**ADDENDUM #4 to PIN 072201931CPD**

Re: Medium Voltage Feeders and Substation  
Upgrades at Rikers Island

# E002.00

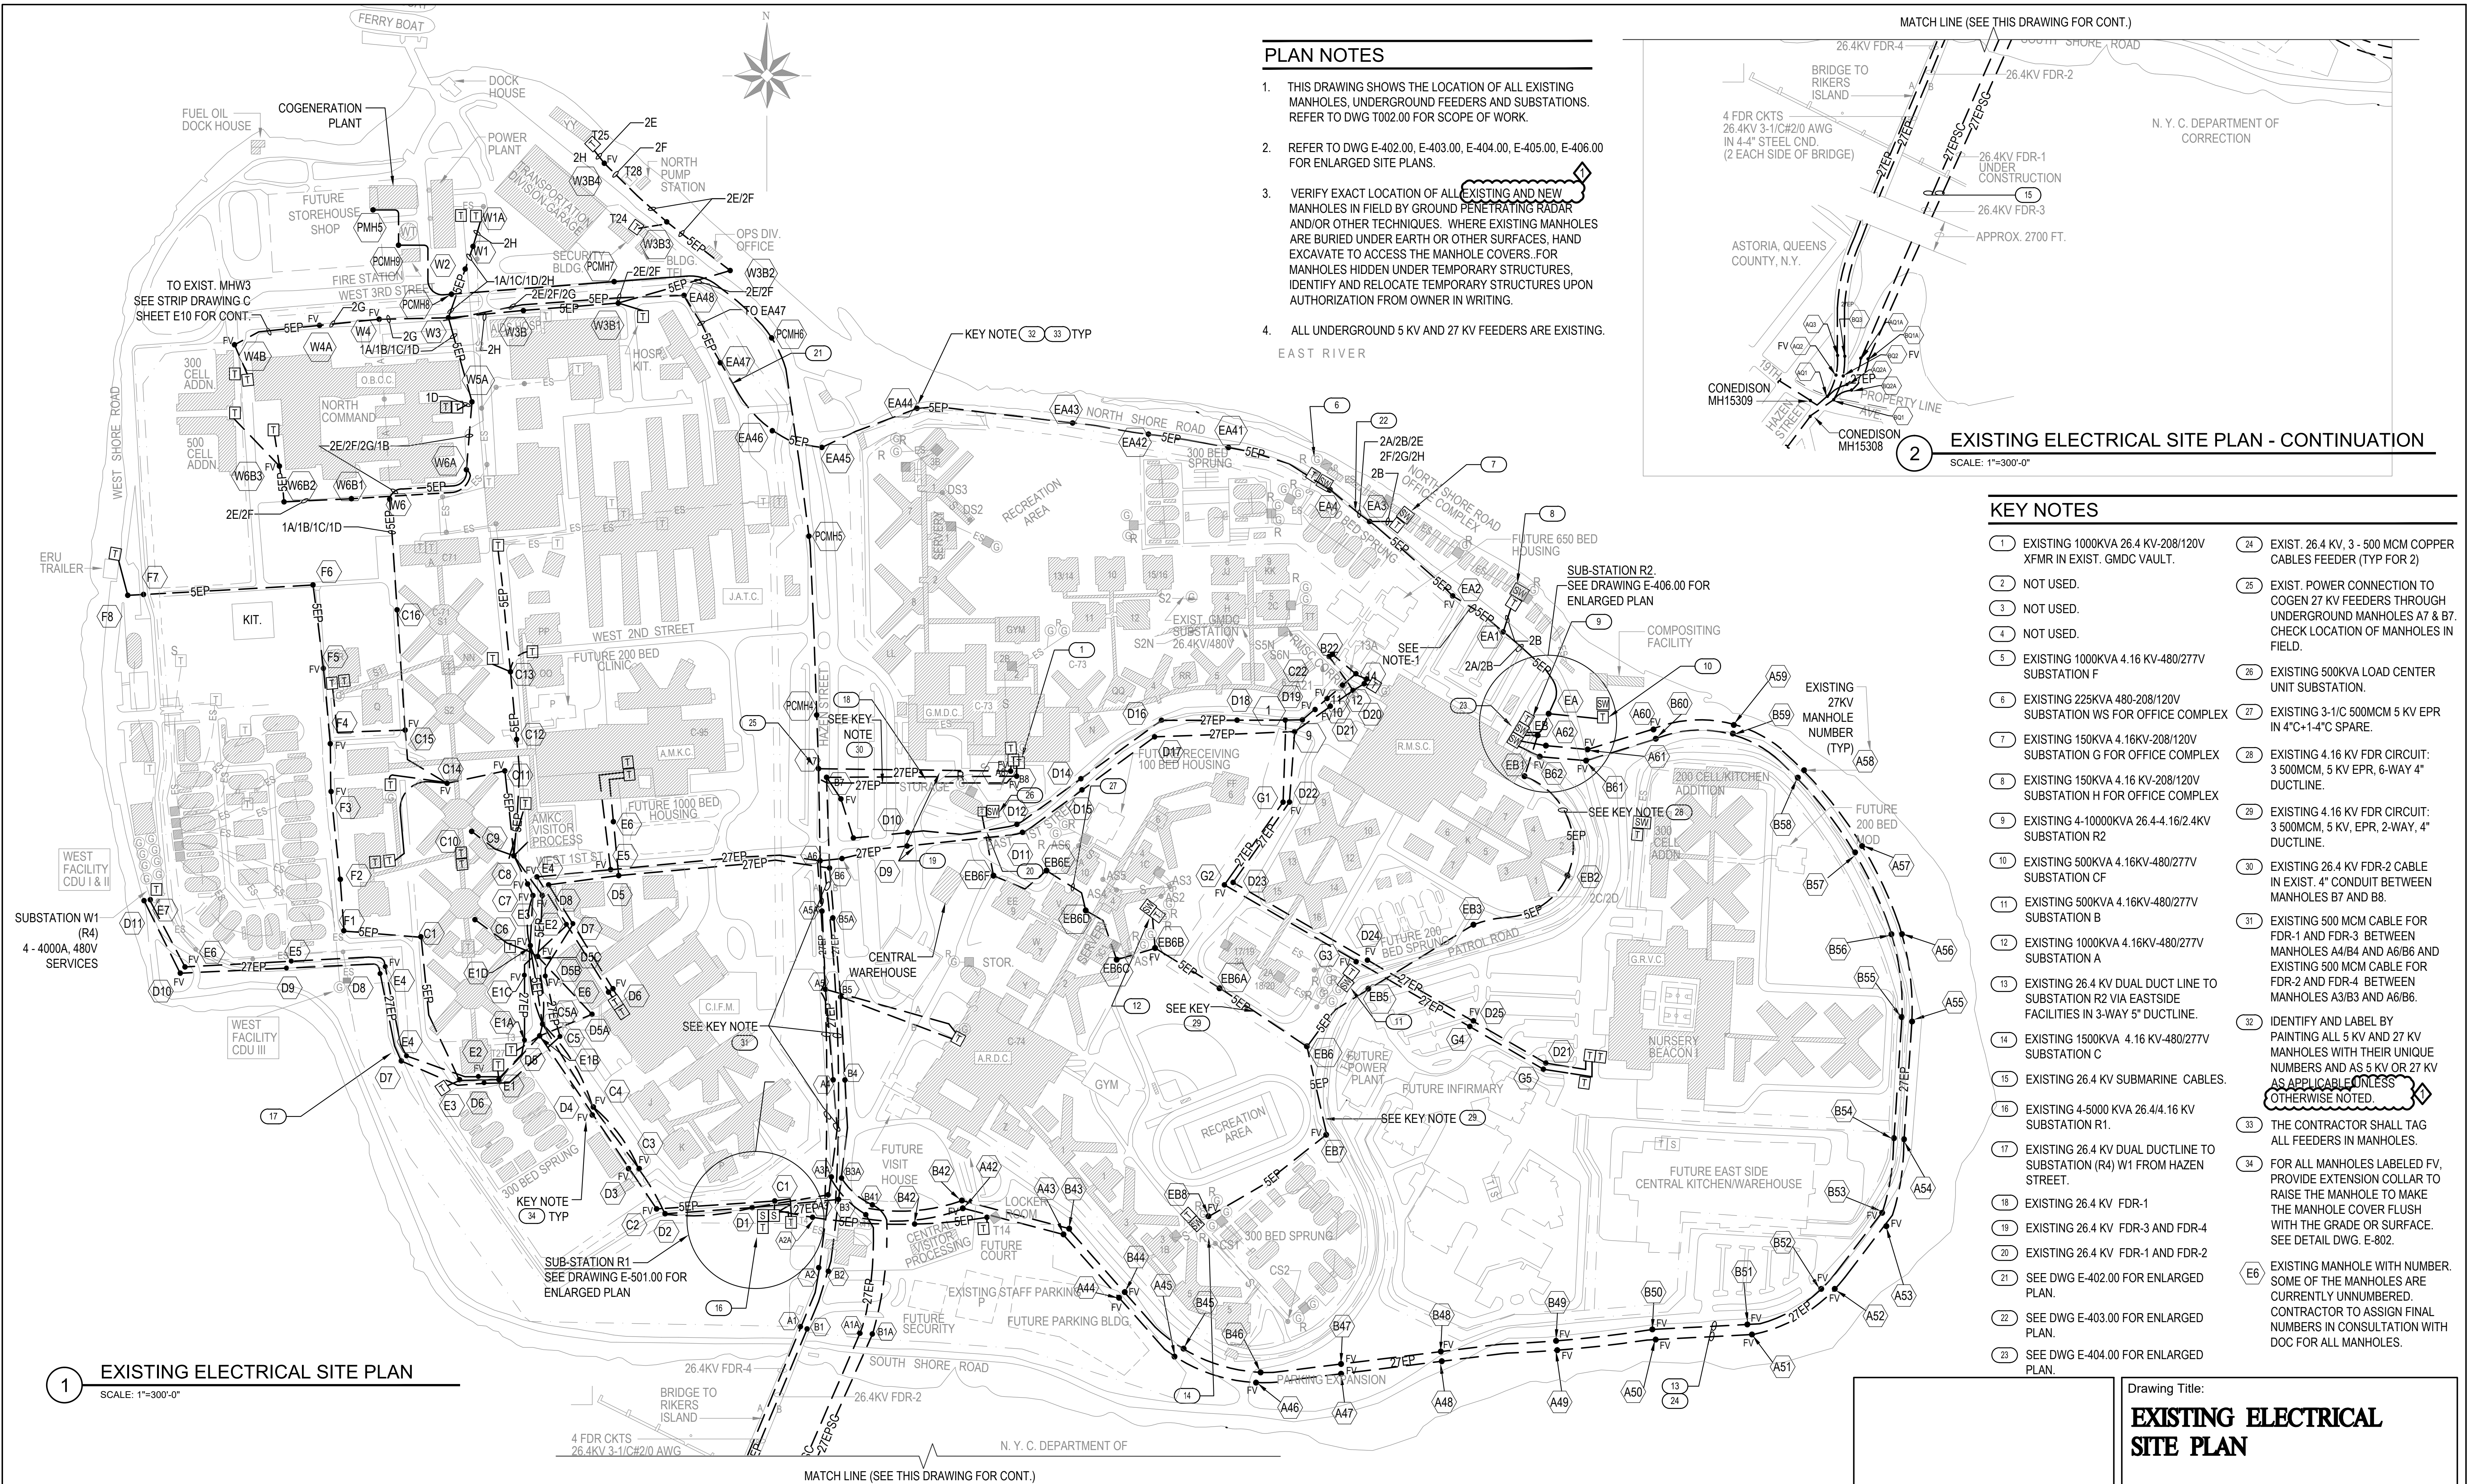
**Q.10** Please provide specifications for pumping manholes.

**Q.11** During the site visit, the Engineer stated that there is a limited amount of water that could be pumped into the sewers. Is the limit per day or per manhole?

**A.10** See notes on pumping of manholes on addendum drawing E-002.00.

**A.11** See notes on pumping of manholes on addendum drawing E-002.00. The discharge and manhole volumes determine where the water is discharged.
